Access Compliance Report

Public Rights-of-Way

(Curb Ramps)

Intersection ID: 16295	Main Street: MARSH_RD	Cross Street: STONE_ORCHARD_PL	Location: SE
ADA ID: C463F1014B96	Ramp Type: PerpDiag	Initial Pass/Fail: Fail	Overall Compliance: No
			Severity Score: 26.25

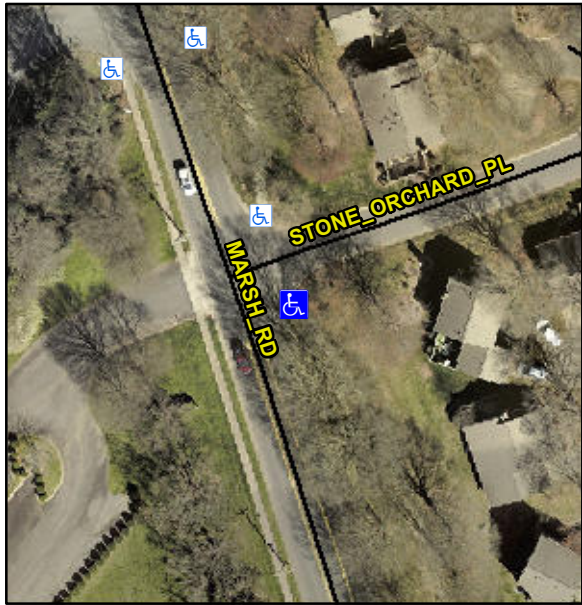
Codes/Mitigation Info/Possible Solution			Field Measurements/Component Compliance					
	Possible Solutions:		Compliance	Description	Data	Compliance	Description	Data
	Remove & Replace Curb Ramp With Two New Directional Ramps or Equivalent.		N/A	Ramp Length (in)	78.0	No	Ramp Slope (%)	13.7
			Yes	Ramp Width (in)	48.0	No	Ramp XSlope (%)	3.4
			N/A	Flare Type LT	N/A	N/A	Flare Type RT	N/A
			N/A	Flare Slope LT (%)	N/A	N/A	Flare Slope RT (%)	N/A
			N/A	Flare Traversable LT?	N/A	N/A	Flare Traversable RT?	N/A
			N/A	Landing Length (in)	N/A	N/A	DWS Provided?	N/A
			N/A	Landing Width (in)	N/A	N/A	DWS Contrast?	N/A
			N/A	Landing Slope (%)	N/A	N/A	DWS Length (in)	N/A
			N/A	Landing X Slope (%)	N/A	N/A	DWS Full Width?	N/A
Surveyor Notes:		N/A	N/A	Landing Curb? (Y/N)	N/A	N/A	DWS Offset (in)	N/A
			N/A	Shared Landing?	N/A			
PROW/ADA:			N/A	Gutter Ponding?	N/A	N/A	Gutter Slope (%)	N/A
R304.2.2, R304.5.3			N/A	Gutter Lip Ht (in)	N/A	N/A	Gutter X Slope (%)	N/A

N/A	Painted X Walk1?	No	N/A	Painted X Walk2?	No
				X Walk 1 Direction	To N		X Walk 2 Direction	To W
			N/A	X Walk 1 Width (in)	N/A	N/A	X Walk 2 Width (in)	N/A
				X Walk 1 Slope (%)	2.3		X Walk 2 Slope (%)	3.4
				X Walk 1 X Slope (%)	2.6		X Walk 2 X Slope (%)	0.2
			N/A	Ramp inside XWalk1?	N/A	N/A	Ramp inside XWalk2?	N/A
				Road Slope (%)	1.6	N/A	Clear Space?	N/A
				Road X Slope (%)	3.3	N/A	Clear Space to XWalk (in)	N/A
			N/A	Any Obstructions?	N/A	N/A	Storm Grate/Utility Hazard?	N/A
				Obstruction Type			Storm Grate/Utility Type	
					N/A			N/A
						Yes	Surface Condition? (G/P)	Good
								</
